REVISION NUMBER	DRAWN BY	CHECKED BY	APPVD BY	DATE	REMARKS
A	IPM	VDA	MG	11/03/98	AS-BUILT

71 RM 001A & 106
MODIFICATIONS
ROOF PLAN LEGENDS & NOTES

UNIVERSITY OF CALIFORNIA LAWRENCE BERKELEY LABORATORY
FACILITIES DEPARTMENT

DRAWN BY	VDA	DATE 07/08/99
CHECKED BY	VDA	07/08/99
APPROVED BY	MG	
CAD FILE PATH	00009888	
SCALE	As Noted	
DRAWING NO.	4B71E106A	SHEET E-5
PROJECT NO.	W38005	3 OF 4

1 / E3 PARTIAL ROOF PLAN-CONSTRUCTION

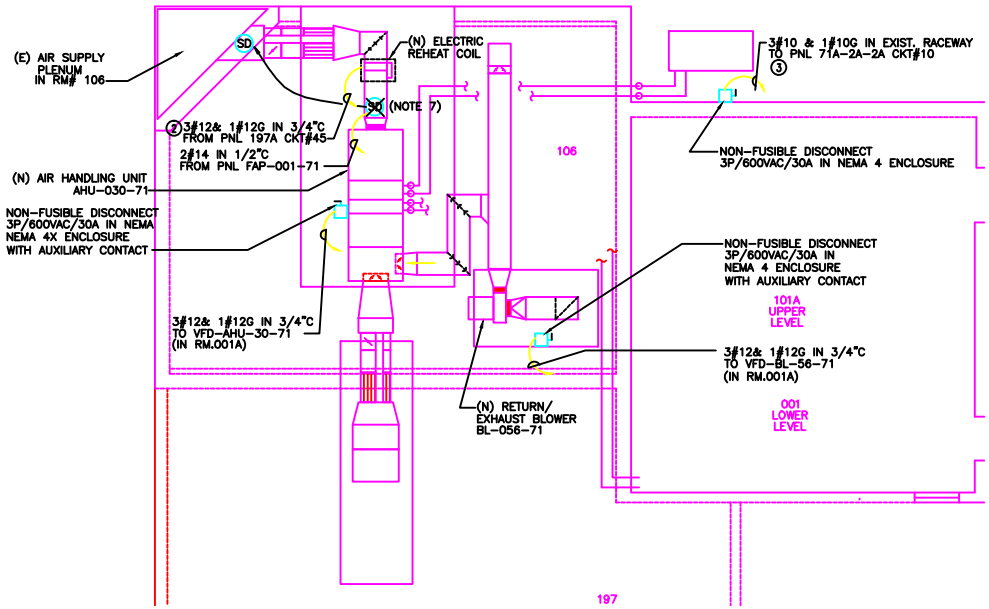
3. CONNECT EXISTING 3P/480VAC/30A SPARE BREAKER #10 IN PANEL 71A-2A PER UPDATED PNL SCHEDULE.
4. ~~ALL DEMOLISHING WORK SHOULD BE COORDINATED WITH JIM AYERS (X5577)~~

5. "LASER ON" PANEL SHOULD BE SIMILAR TO STANDARD PANEL DWG.4BSTE081 & 082 & TO BE INTERLOCKED WITH ON/OFF SWITCH IN RM.001A OF LASER EQUIPMENT.
6. ~~(E) A32, 24" RACK TO REMAIN, EQUIPMENT TO BE REMOVED.~~

7. ~~(E) PA RACK A50 IN RM.001A SYSTEM TO BE RELOCATED TO (E) PA RACK IN RM#001. COORDINATE WITH GLENN SKIPPER (X6125)/ELOY SALINAS (X6968)~~
8. ~~(E) RACK A36 TO REMAIN, EQUIPMENT PARTIALLY REMOVED, RELOCATE FROM RACK A36 TWO STACKS WITH EQUIPMENT TO RACK A35, RACK A36 TO BE REMOVED. ALL WORK SHOULD BE COORDINATED WITH JIM AYERS (X5577)~~

9. ~~(E) LIGHTING FIXTURES IN RM.001A TO BE CLEANED/RELAMP/REBALLAST AS REQUIRED.~~
10. ~~(E) LIGHTING FIXTURES IN RM.106 TO BE RELAMPED WITH METAL HALIDE 100W, 120V LAMPS (MH100/U/M) & REBALLAST WITH INSTANT START BALLAST. CONNECT TO CKT.#1 & 3 IN PNL 197A. REROUTE (E) RACEWAY FROM PNL 71A-2A-2A TO PNL 197A. FIELD TO CHECK POSSIBILITY OF REUSING (E) WIRES IF NOT RUN NEW 4#12 &1#12G. IN PNL71A-2A-2A DISCONNECT WIRES FROM CKT.BKR.#2. LEAVE THIS BKR AS SPARE.~~

11. ~~(E) GRID TO BE REMOVED. CABLES TO BE CAREFULLY CHECKED. NOT USED CABLES TO BE REMOVED & REROUTE THE CABLES IN USE. COORDINATE WITH JIM AYERS (X5577).~~
